Submit I Copy To Appropriate District	State of New Mexico				Form C-103
Office v <u>District I - (575) 393-6161</u>	Energy, Minerals and Natural Resources				October 13, 2009
1625 N. French Dr., Hobbs, NM 88240				WELL API NO.	
<u>District II</u> – (575) 748-1283 811 S. First St., Artesia, NM 88210	OIL CONSERVATION DIVISION			30-015-21809	
District III - (505) 334-6178	1220 South St. Francis Dr.			5. Indicate Type	
1000 Rio Brazos Rd., Aztec, NM 87410	Santa Fe, NM 87505			STATE 6. State Oil & G	
<u>District IV</u> – (505) 476-3460 1220 S. St. Francis Dr., Santa Fe, NM	Saita 1 0, 1414 07303			o. State Off & O	as Lease No.
87505					
	ICES AND REPORTS ON				or Unit Agreement Name
(DO NOT USE THIS FORM FOR PROPOSALS TO DRILL OR TO DEEPEN OR PLUG BACK TO A DIFFERENT RESERVOIR. USE "APPLICATION FOR PERMIT" (FORM C-101) TOPA SUCH				Delhi State	Ĵ
DIFFERENT RESERVOIR. USE "APPLICATION FOR PERMIT" (FORM C. 1914 ASUCH PROPOSALS.)  1. Type of Well: Oil Well  Gas Well  Gas Well				8. Well Number

Delhi St #4

API# 30-015-21809

#### CONDITIONS FOR PLUGGING AND ABANDONMENT

Delhi St #4

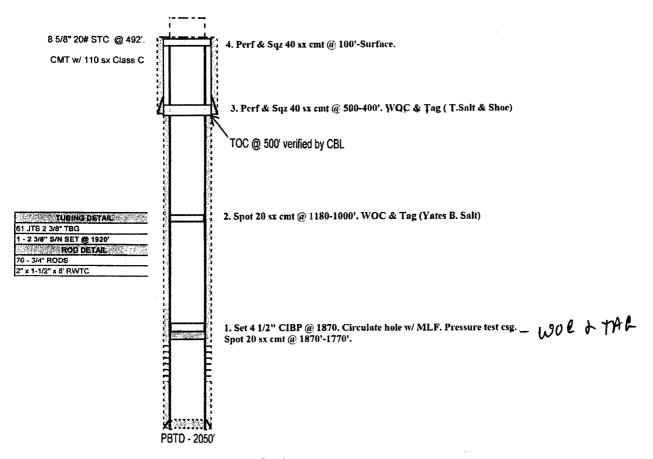
1. Set 4 1/2" CIBP @ 1870. Circulate hole w/ MLF. Pressure test csg. Spot 20 sx cmt @ 1870'-1770'. — WTE > TAL					
2. Spot 20 sx cmt @ 1180-1000'. WOC & Tag (Yates B. Salt)

3. Perf & Sqz 40 sx cmt @ 500-400'. WOC & Tag ( T.Salt & Shoe)					
4. Perf & Sqz 40 sx cmt @ 100'-Surface.  5. Cut of well head, weld on Dry Hole Marker.  Approved for plussias of well bore only.  Approved for plussias recained pending receipt  Approved for plussias recained pending receipt  Approved for plussias of well bore only.  Approved for plussias of well bore only.
